Washington Public Power Supply System

Docket 50-508

October 22, 1982
G03-82-1085

Subject: WASHINGTON NUCLEAR PROJECT 3
RESPONSES TO NRC ACCEPTANCE REVIEW
QUESTIONS

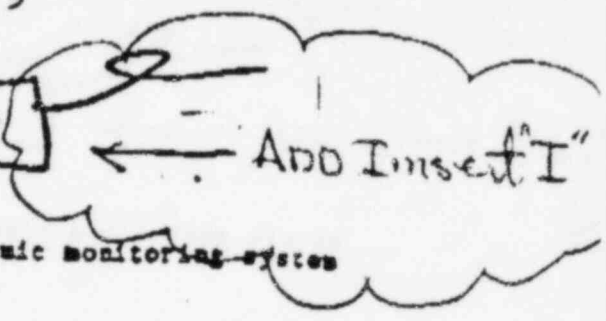
220.4 (3.7.4) Provide an FSAR Subsection 3.7.4 on seismic instrumentation as outlined in the Standard Review Plan (NUREG-0800) and Regulatory Guide 1.70.

The Seismic Monitoring System is discussed in FSAR Subsection 7.6.1.1.7. FSAR Subsection 3.7.4, Seismic Instrumentation, as required by Regulatory Guide 1.70 will be added to the FSAR and will reference the Seismic Monitoring System.

ATTACHMENT 1
 (NRC QUESTION 241.6)
 PLANT LOCATION CONTOUR MAP
 TOP OF WEATHERED SANDSTONE

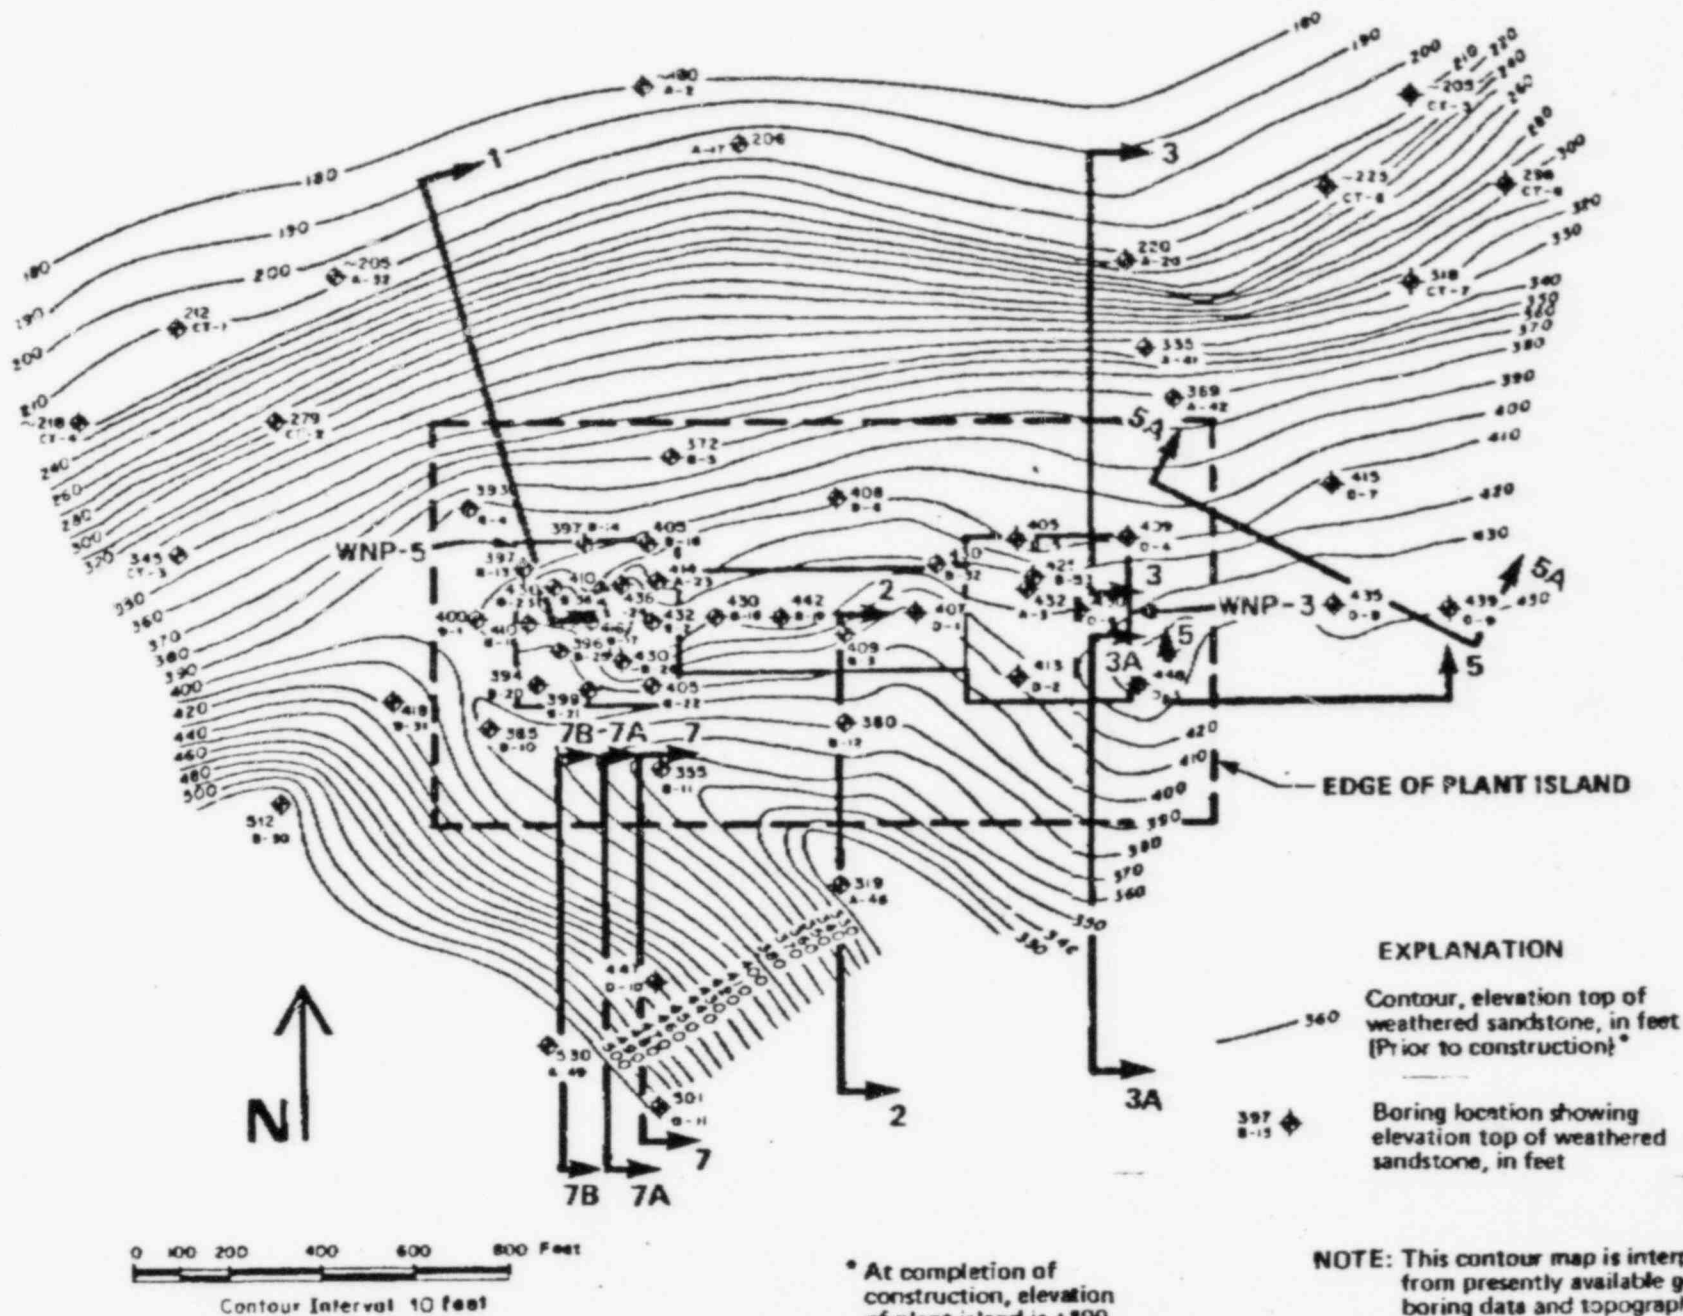
241.5
(2.5.5.1) You mention that the slopes selected for stability analysis were those bounded by the interpreted surface of the weathered sandstone, shown on Figure 2.5-124. You have not included this figure in the FSAR. Provide the figure or a correct reference to its location in the FSAR.

The correct reference is Figure 2.5-100.

WASHINGTON PUBLIC POWER SUPPLY SYSTEM
Nuclear Projects 3 & 5
FINAL SAFETY ANALYSIS REPORT
FLOW DIAGRAM - CIRCULATING,
SERVICE AND PLANT MAKE-UP
WATER SYSTEM
FIGURE 9.2.1-1

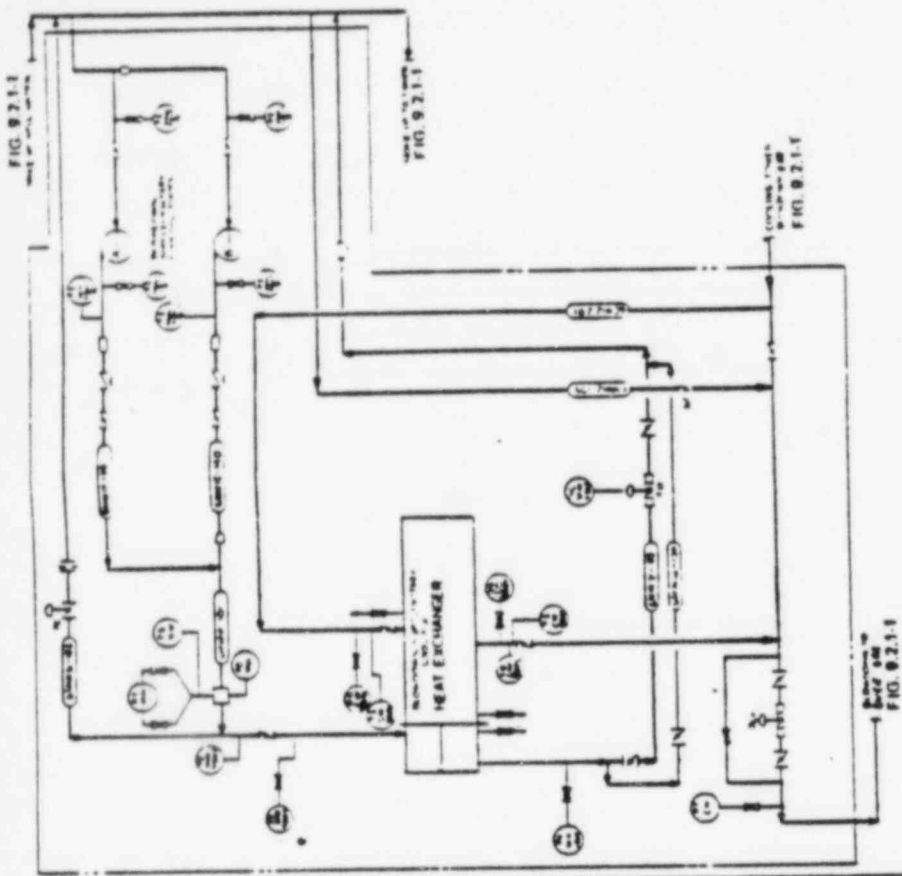
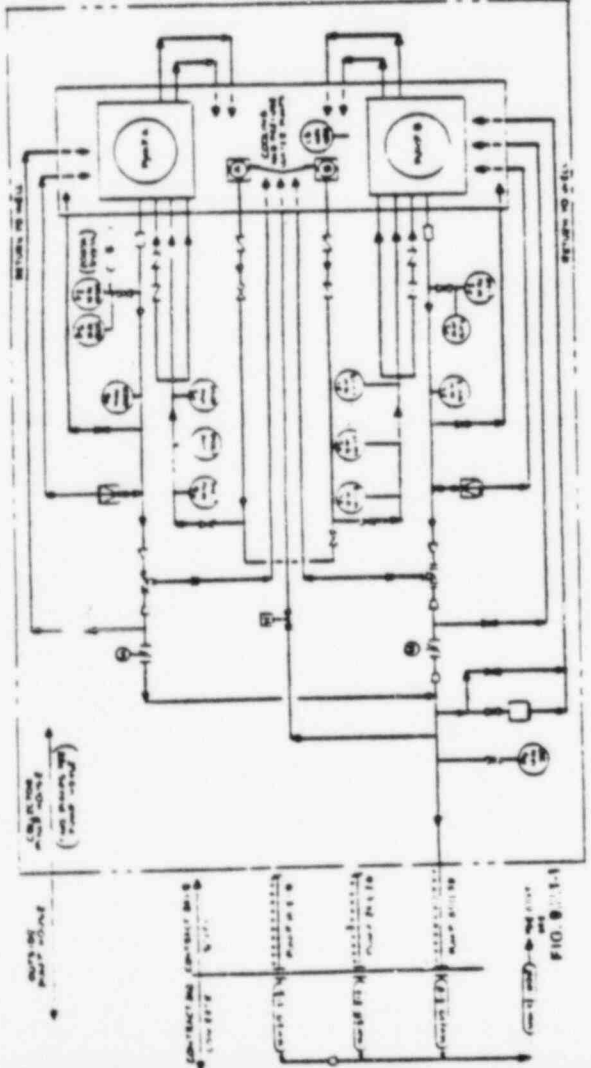
410.10 Subsection 9.2.8 does not contain Figure 9.2.8-1; provide this
(9.2.8) drawing or a date by which it will be supplied.

The Plant Makeup Water System flow diagram was included in the FSAR as Figure 9.2.1-3. This figure number will be revised to Figure number 9.2.8-1.

Q480.6
10613

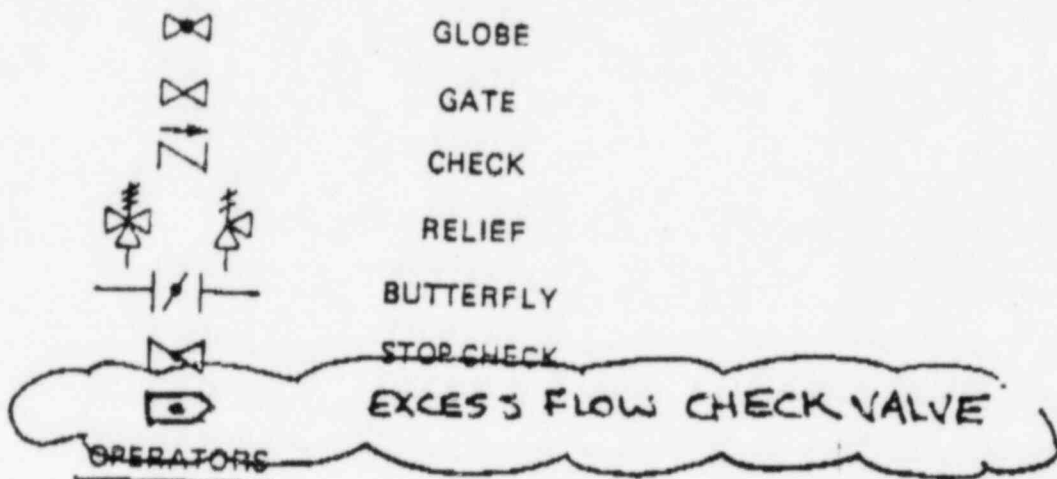
480.6 Provide instrument lines containment penetration information in Table 6.2.4-1 and Figure 6.2-36 which is labeled as "later".

Table 6.2.4-1 and Figures 6.2-36 through 6.2-36r provide details of the instrument line penetrations.
